## Attachment A: Written Response to Council's Information Request

APPLICATION REFERENCE: A006953659

ADDRESS OF SITE: 79 ANNIE ST, NEW FARM QLD 4005

**Plate 1: Site Photograph of rear property boundary and established landscape features.**

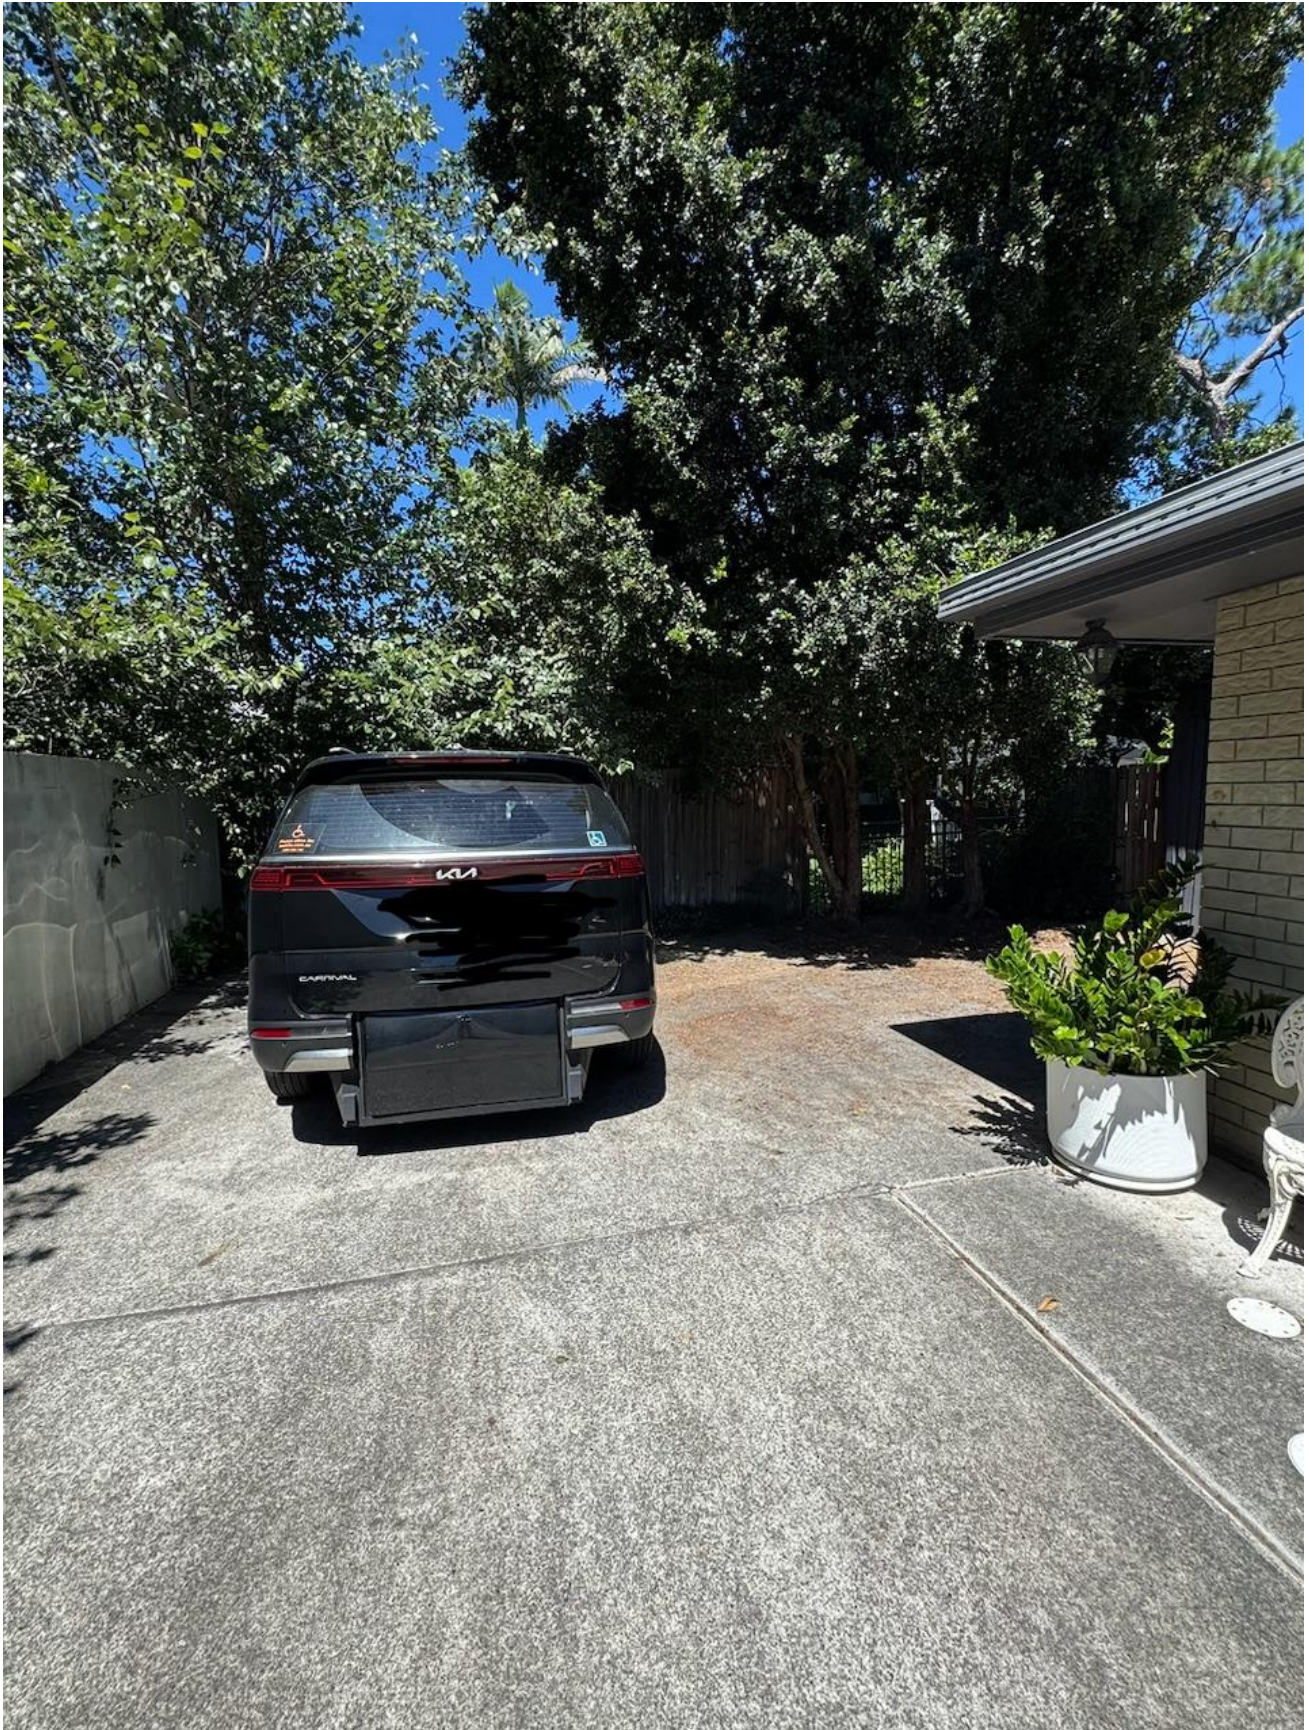
- 3) *The 2002 development approval included a landscaping bed along the rear boundary.*
  - a) *Revise the proposed plans to provide a minimum 0.6 metre wide landscaping area along the length of the Unit 5 rear boundary to reduce amenity impacts and soften the built form.*

**Our Response:** There is an existing well established landscape edge along the rear property boundary ranging in width from 500mm to 2335m wide. The established screening shrubs are deemed sufficient to soften existing and proposed built form.

Some existing site photos of the rear boundary are provided below for reference.
